Trillium Health Partners – Credit Valley Hospital

**Oncology Radiation Treatment Expansion
Cumulus Architects Inc. Project No.: 23010
WSP Project No.: CA0003678.3329**

ISSUED FOR ELECTRICAL ADDENDUM 1

February 4, 2026

3 SECTION A
E506 1:50

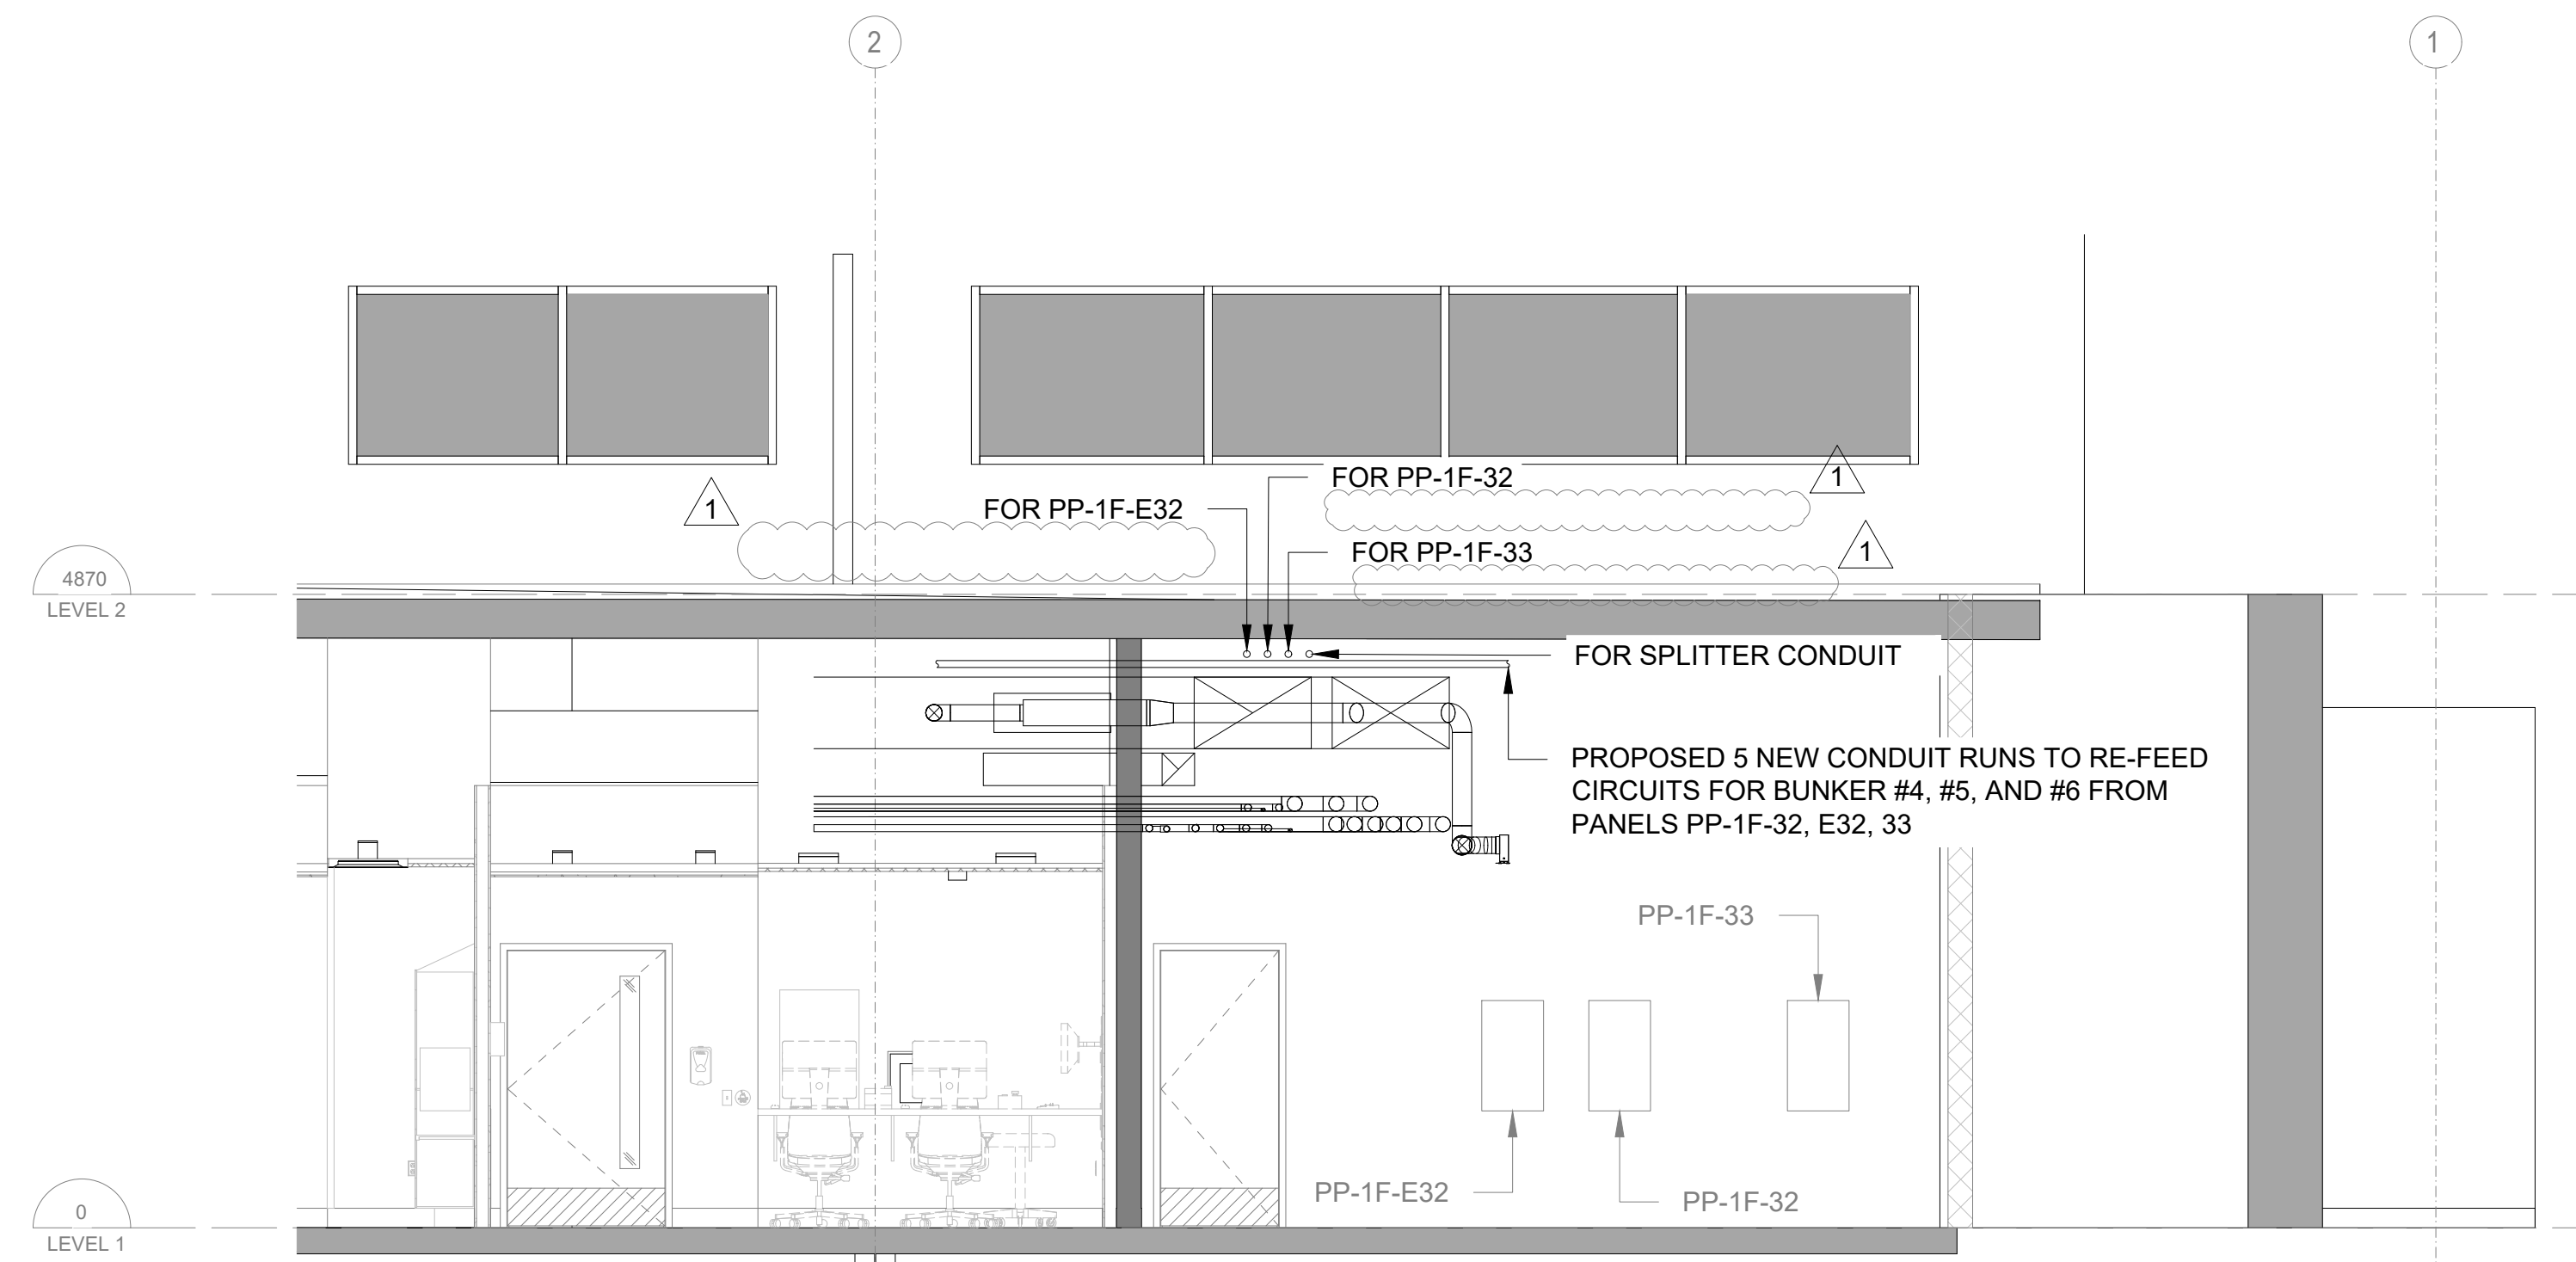
1.2.1 Revised Detail 3 to remove feeder sizing, refer to feeder labels in Detail 1.
